Product Change Notification

Title: **PCN #2023006 TDK-Lambda Americas Inc. PAF600F280 series control IC change**

Figure 1: PAF600F280 output adjustment range vs. input voltage

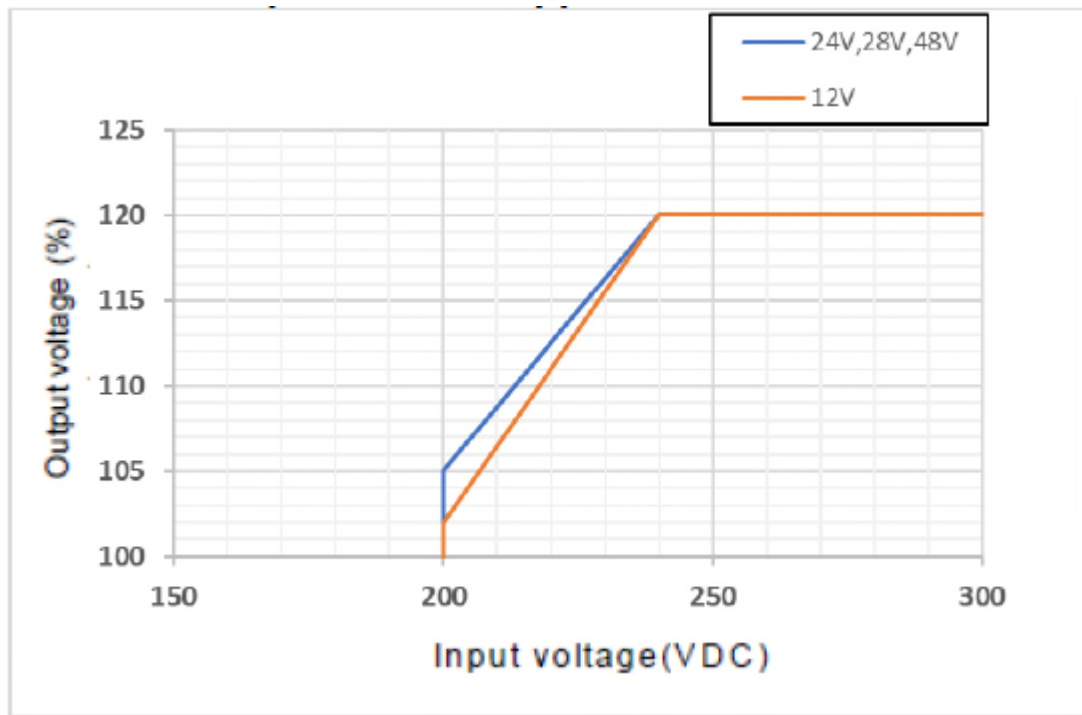
1. The PAF600F280-12 maximum ripple and noise specification was 120mV, now 270mV
2. The PAF600F280-12 maximum adjustment range at 200Vdc input was 105% of the 12V nominal voltage, this has been reduced to 102%. See figure 1.
